South Planning Committee

Development Management Report

Application Number: 16/02491/REM	Parish: Church Stretton
Proposal: Approval of reserved matters (appearance, landscaping, layout and scale) pursuant to planning permission 14/01173/OUT for residential development (up to 52 dwellings) to include access	
Site Address: The Leasowes, Sandford Avenue, Church Stretton, Shropshire SY6 7AE	
Applicant: Mr R.Hill	
Case Officer: Grahame French	email: planningdmsw@shropshire.gov.uk

Figure 1 – Proposed site layout

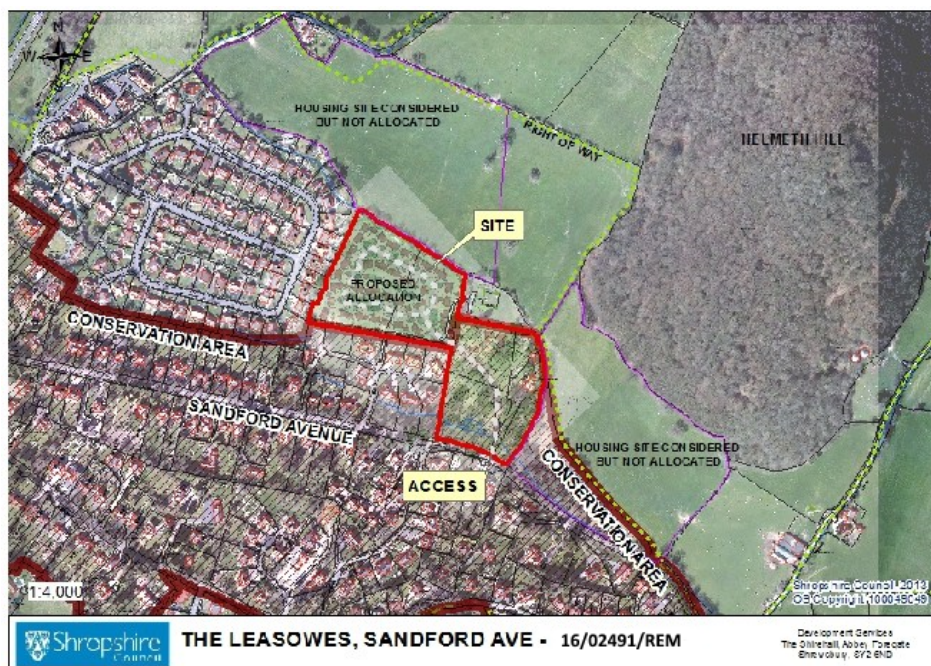
i. The submission of the revised arboricultural report (OOTC/PC17/162/rev.1) and arboricultural method statement (Ref. OOTC/PC17/1621/MS/rev.1) coupled with revised site layout (Ref. 1628 – P-01.Rev.J) and the revised general arrangements plans submitted on the 26th June 2017 go a long way towards allaying many of the concerns raised in the Tree Service's previous consultee comments. It is however our considered opinion that there are a number of issues that have still not been addressed to a level of detail to satisfy the requirements of conditions / reserved matters 1(iv) – 6(a) & 8(a) in summary those are:

- The unnecessary impact of plot 21 on two protected trees (See 1.3 below).
- An incomplete tree protection plan and Arboricultural method statement with some site layout disparity between the revised arboricultural plans and the revised block plan (see 2.1, 2.2, & 2.3 below).

- The impacts of the mixing storage and parking areas on the proposed zone identified for tree planting has not been addressed (See 2.3 below).
- The short and long-term implications on mitigation planting from excavations for and the laying of service pipes between plots 20 & 21 and the main area of the development through an area identified for tree planting has not been addressed (See 2.3 below).

- Incomplete landscape plan with conflicts between the tree planting plan and the block plan (See section 3.1, 3.2 & 3.3 below).
- The failure of the applicant to reinstate the provision to include a road side lime avenue on the main drive and compensatory planting at the site entrance in the landscape mitigation proposals (See 3.1.3 & 3.2.1 below).

ii. From an arboricultural perspective the revised block plan 1628–P01.Rev.J is significantly different to the iterations of the proposal offered at outline in that the access road design has changed significantly and that previous arboricultural submissions did not include dwellings on the plots now identified as plot 20 & 21. Also of significance is the erosion of the aspiration to maintain a wide garden buffer between the new development and the existing estate to the west that would have been large enough to include meaningful structural tree planting that would integrate / screen this development in the landscape as seen from the west and north-west. It is still not clear why the building on plot 21 has to be set so far forward. This brings the dwelling closer to the protected trees than fits with good sustainable design because it is predictable that the size and species of the trees (2

- Mixing station, site huts, parking zones & general arrangements - The block plan (1628-P-01/Rev.J) and general arrangement plan (LO-GA-40 Rev.A) show activities such as service runs the storage of materials and a concrete mixing station within an area identified in the proposed landscape mitigation plans for

The lack of consideration or poor level of communication for these implications on the long-term success of the planting proposal is highlighted by the fact that the tree protection plans PC17/162/TPP/1 and PC17/162/TPP/rev.1 show the mixing station, site storage, and parking areas in a completely different location to their position as shown on the revised block plan 1268-P01-Rev.J.

- ix. Other landscape provisions - Plan 1628 – P-01.Rev.J carries a small list of proposed planting but does not clearly show on the plan where the planting will be established. Further to this the proposed hedge planting mix as shown on the plan is different in its mixture to that stated in section 7.5.6 of the design and access statement. A rudimentary comment on plan 1628–P01.Rev.J coupled with an indicative planting schedule in the design and access statement does not constitute an appropriate landscape plan for a development of this scale and prominence. We would advise that as well as a tree planting plan the Council secure a proper working and binding stand-alone landscape plan with comprehensive planting schedules and specifications for all other hard and soft landscape (Footpaths bridges and steps etc.) that can be used and interpreted accurately in a landscape tender and by contractors and Council Planning Officers alike. During the outline application discussions on site layout resulted in the buildings along the Alison Road Boundary having small front gardens and extended back gardens, this was in part to accommodate a series of potentially large trees along the boundary that would help to embed this large development into the local landscape. Plan 1628-PO1-J appears to have dispensed with this consideration giving rise to small back gardens reducing the potential for garden planting to improve the areas character and amenity. For a development with the potential to impact on the character of the area as seen from the surrounding hills we find the contradictory and less than

- 7a. An updated tree protection plan shall be submitted to and approved in writing by the Local Planning Authority prior to the commencement of the development. The plan shall in particular provide the following details:
 - i. Details of how any drainage will be constructed past the Root Protection Area of the mature tree in the garden of number 36 Alison Road;
 - ii. Details of how the water balancing tanks associated with the proposed site access road will be constructed without impacting on Root Protection Areas;
 - iii. A method statement for constructing the proposed footpath and raised wooden walkway without impacting on Root Protection Areas.
 - iv. Confirmation that the proposed alignment of the access road (as shown on plan CS-AR-002 - Junction Bellmouth and Junction Visibility) will not adversely affect the Root Protection Area of any mature trees.

- 10a. No development shall be commenced until full updated details of hard and soft landscape works have been approved in writing by the local planning authority and these works shall be carried out as approved. These details shall include:

Note: The scheme should considering the potential for provision of an avenue of lime trees along the proposed access road, for the planting of 2 additional limes adjacent to the access on the public highway and for additional shrub / hedgerow planting along the western and southern site margins.
